Addendum No. 1

City of Coquitlam
Tender 77103
Austin Avenue Improvements (Brookmere MUP – Walker St)
 (Consists of 8 Pages)

Issue Date: March 10, 2023

DRAWING NUMBER:
COQ-L2C

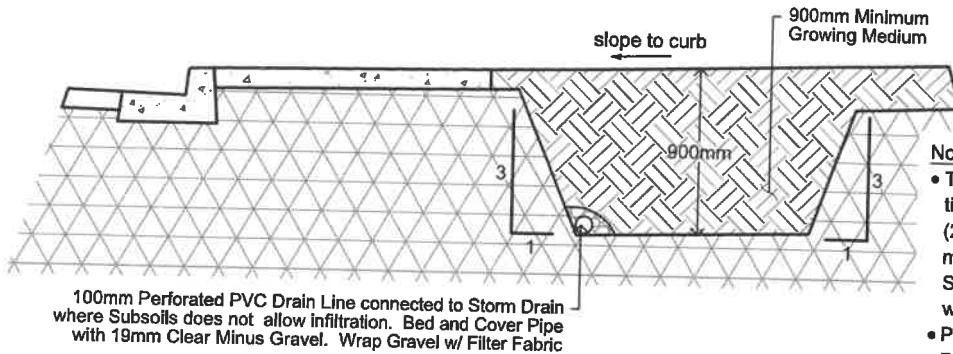
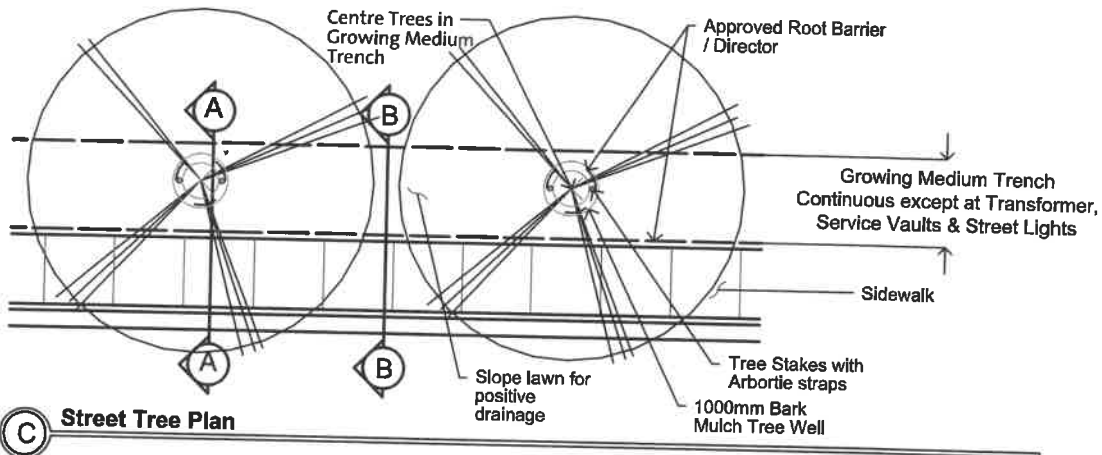
ADD: Coquitlam Standard Detail Drawing, COQ-L2C

- Q7) How high will the optional chain link fence be?
- A7) New chain-link fence to be 5 feet in height.**
- Q8) Can you please provide a planting detail for the trees and shrubs – soil requirements, root barrier?

- A8) See Appendix B – Additional Documents for tree planting detail (COQ-L2C)**
- Q9) The quantity of soil seems high at 620 cu.m.
- a. The area of hydroseed (for the boulevard) is 110 sq.m. Which should coincide with the soil – therefore 16.5 cu.m.
